VT ROUTE 17 (RURAL MINOR ARTERIAL) - BRIDGE #2

RECORD PLANS	
CONTRACTOR:	S. D. IRELAND CONC. CONST. CORP - BURLINGTON, VT
RESIDENT ENGINEER:	JOE KNIPES
CONSTRUCTION BEGAN:	OCTOBER 9, 2013
CONSTRUCTION COMPLETE:	DECEMBER 6, 2013
RECORD PLANS BY:	JOE KNIPES & AARON JAMES
I HEREBY CERTIFY THAT ALL THE CONSTRUCTION REQUIRED BY THIS SET OF DRAWINGS HAS BEEN ACCOMPLISHED AS INDICATED HEREIN.	
BY:	RESIDENT ENGINEER
DATE: 6-29-16	<i>[Signature]</i>
	<i>[Signature]</i>
NOTE: Any further information concerning final quantities, amounts or other details relative to this project may be found at Central Files in the electronic archives.

PRECAST CONCRETE BOX CULVERT SHOP DRAWINGS (SDI JOB #13510)
SUPERVISOR: M. WHEELER
DETAILER: C. DUPLANTIS
CHECKER: M. WHEELER
ENGINEER: ENGINEERING VENTURES
PROJECT NAME: ADDISON
PROJECT #: STP CULV (14)
LOCATION: ADDISON, VT
BRIDGE: #2 ON VT ROUTE 17

Plan View

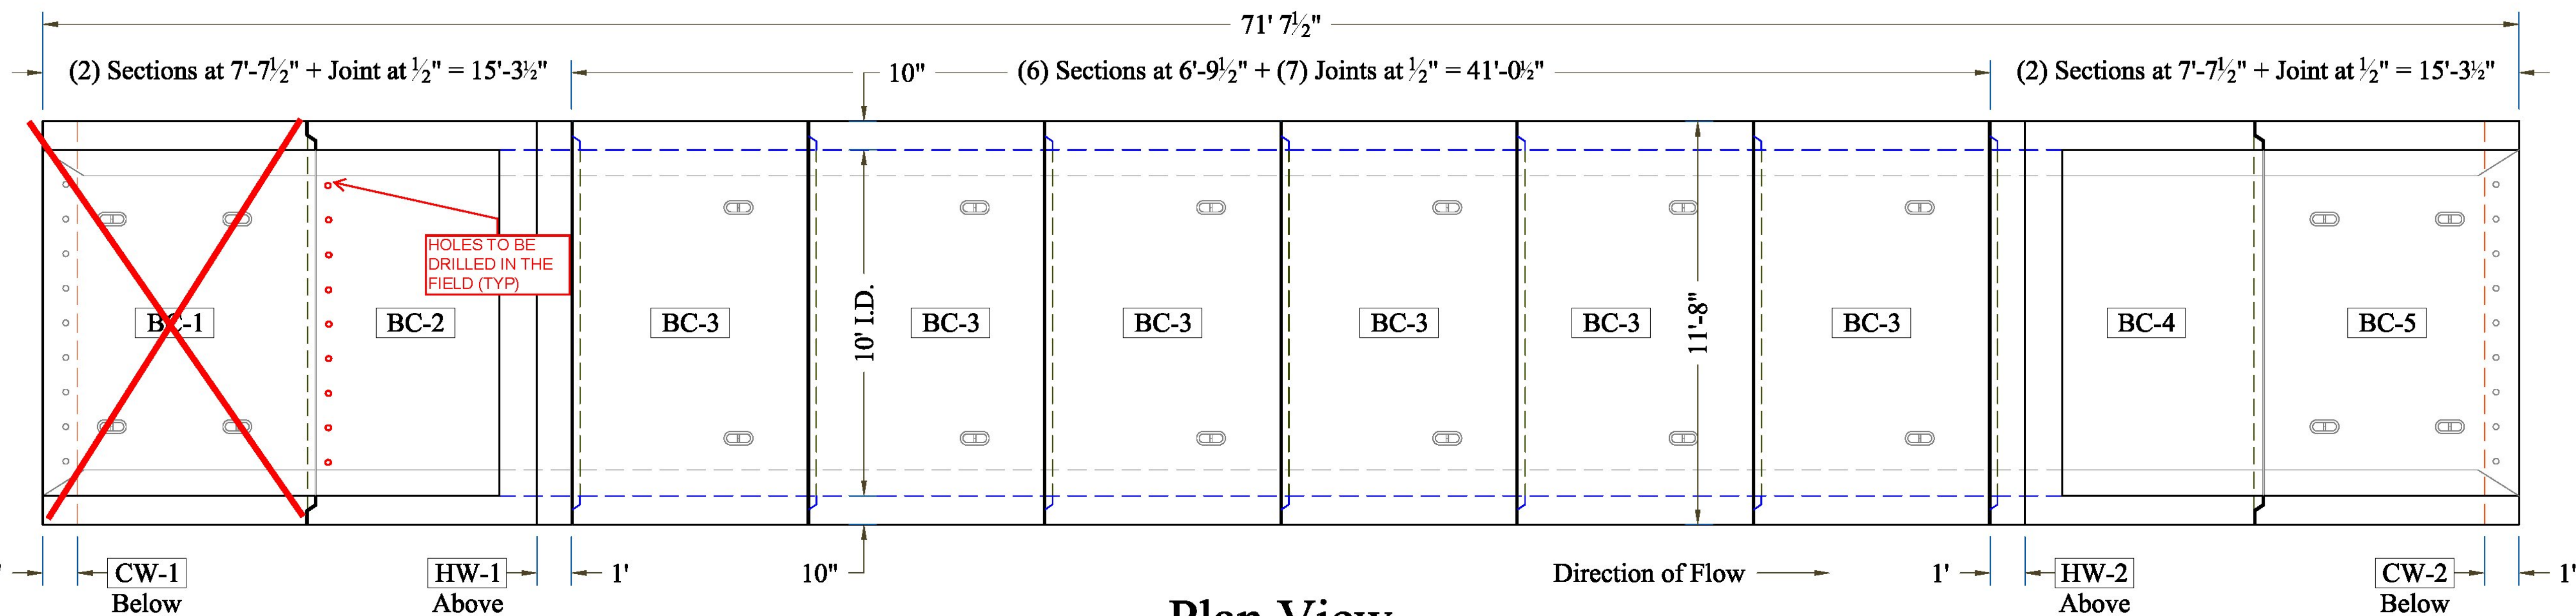
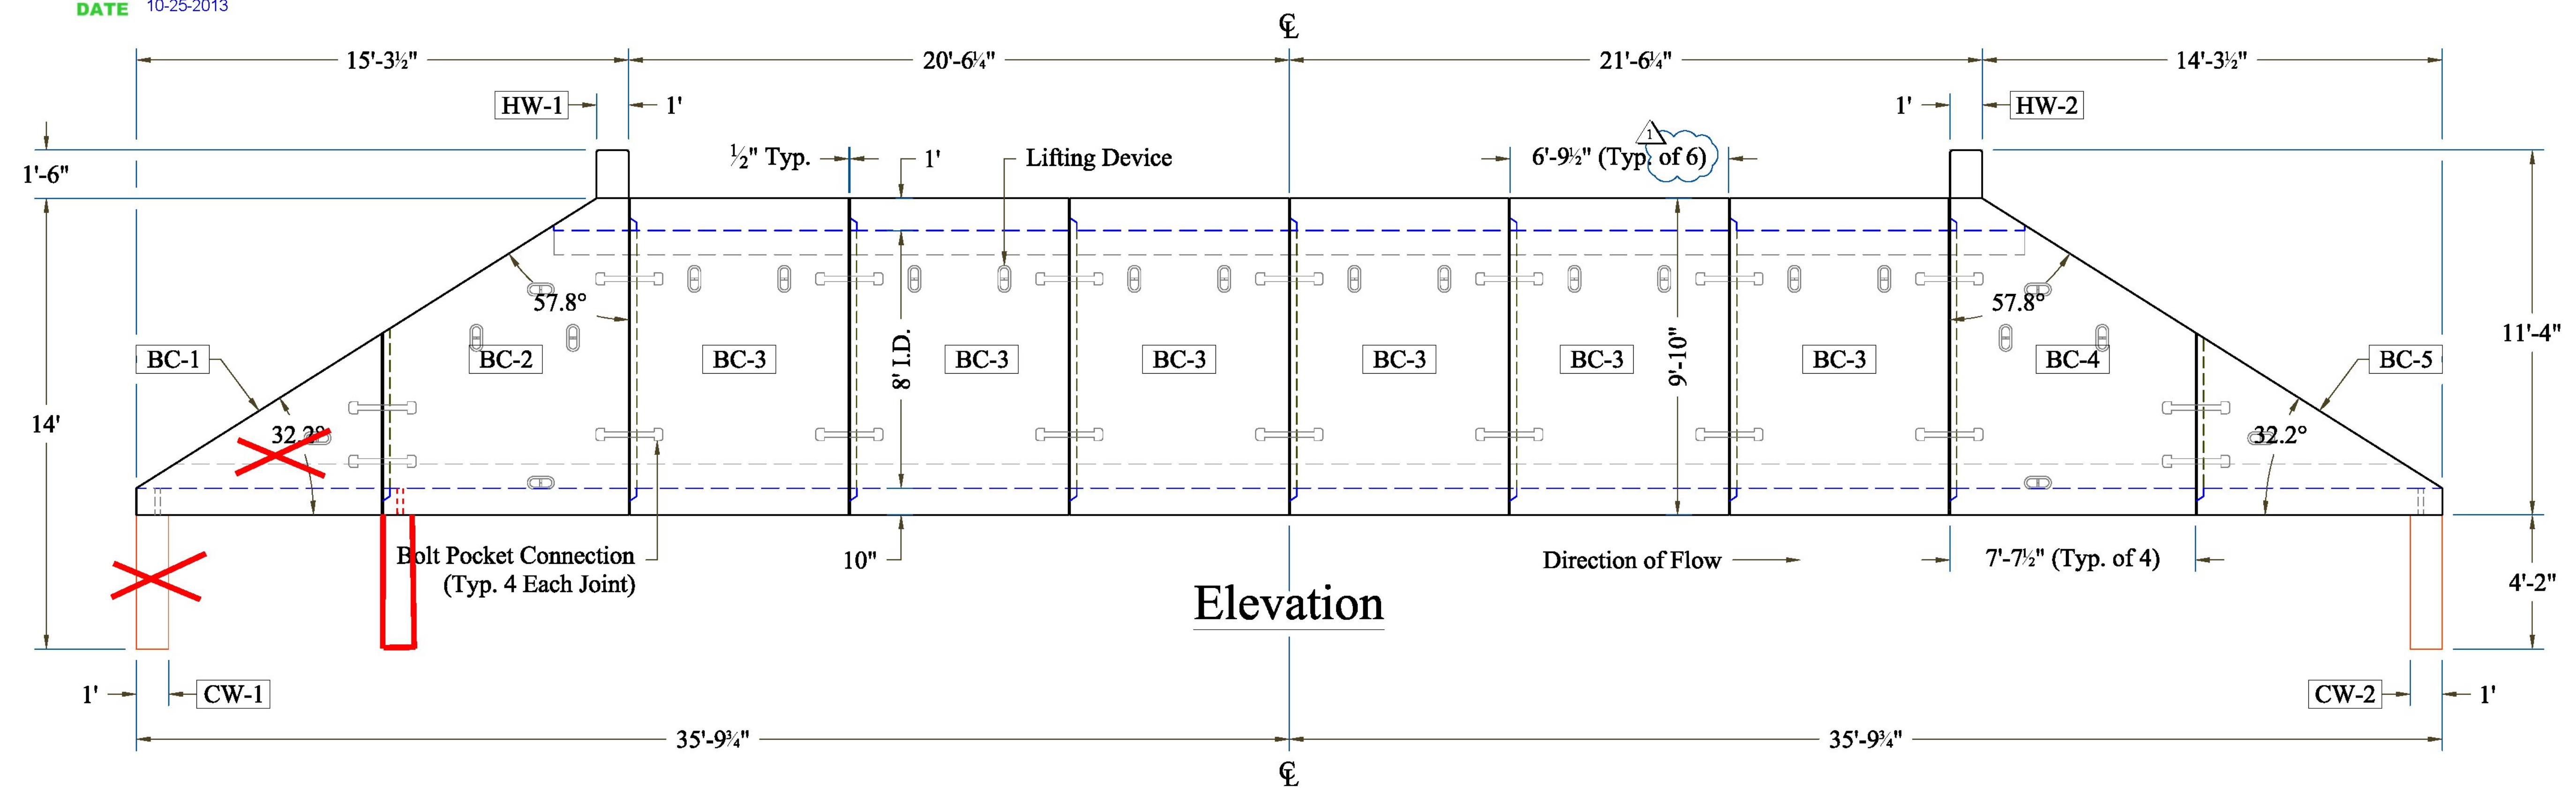
REVISED 10-25-2013 JTS
 BC-1 HAS BEEN OMITTED AND WILL NOT BE FABRICATED.
 HOLES FOR FOR DOWELING CUT OFF WALL SHALL BE ADDED TO BC-2

RESUBMIT NO Approved AsNoted
 BY KH DATE 10-25-2013

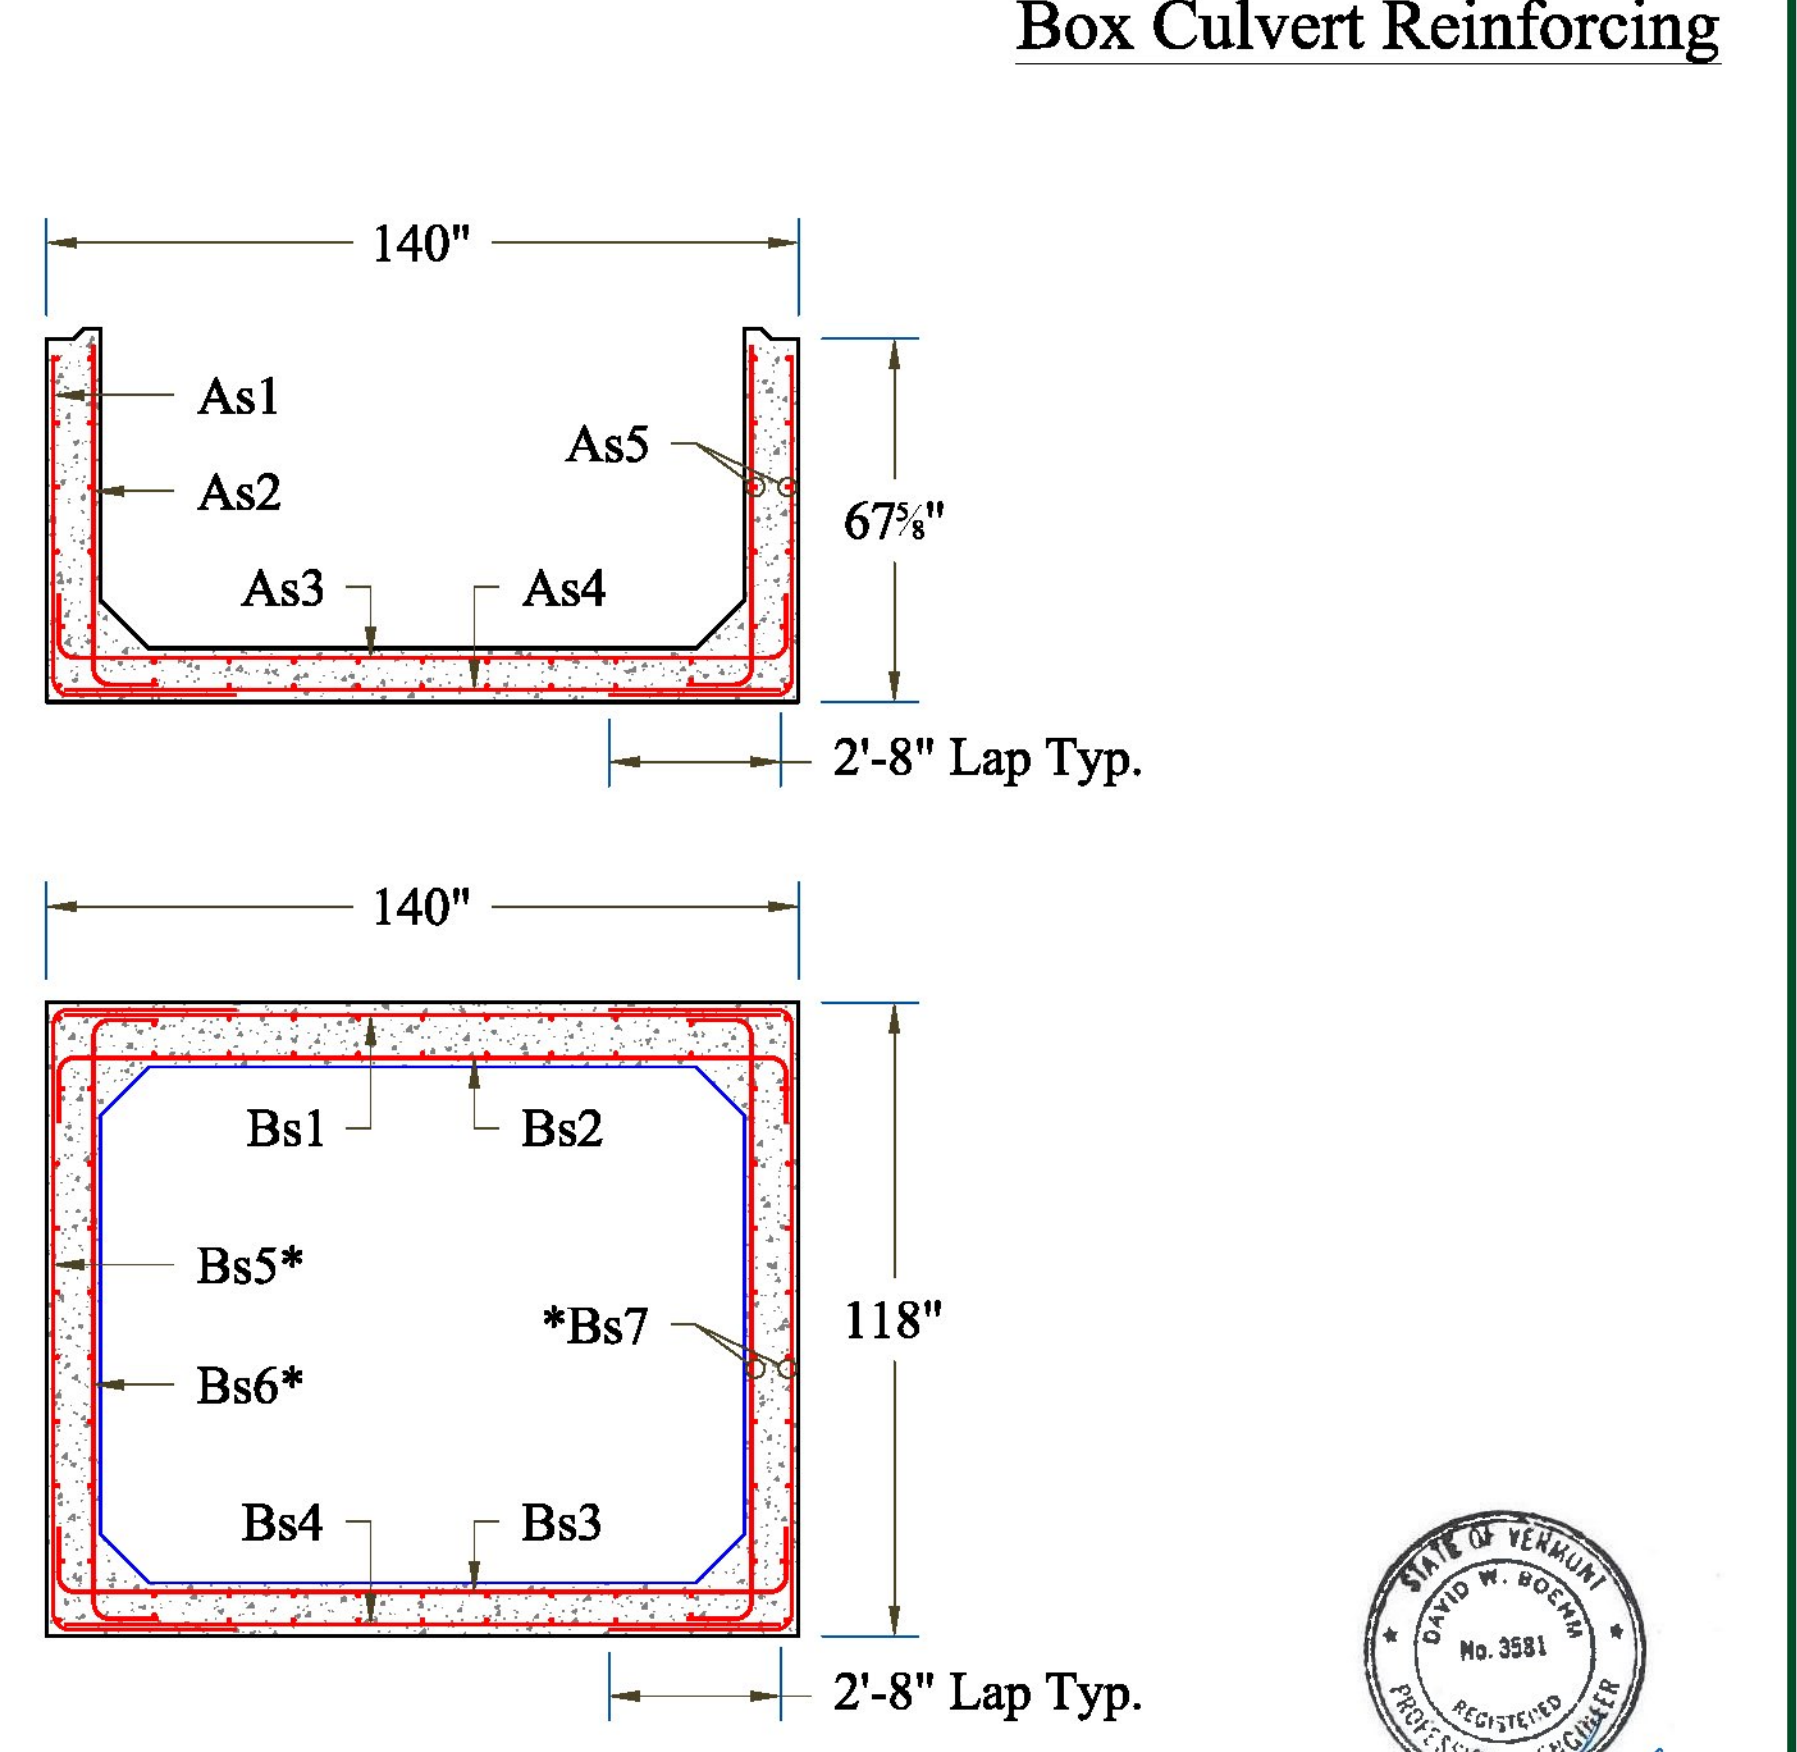
these longitudinal bars can be slightly longer because they protrude into the lip. ASTM C1433 specifies they are to be 1/2" to 2" from the outside face of the lip. an extra 1" on these would be ok.

REVISED 10-25-2013 JTS
BC-1 HAS BEEN OMITTED AND WILL NOT BE FABRICATED.
HOLES FOR FOR DOWELING CUT OFF WALL SHALL BE ADDED TO BC-2
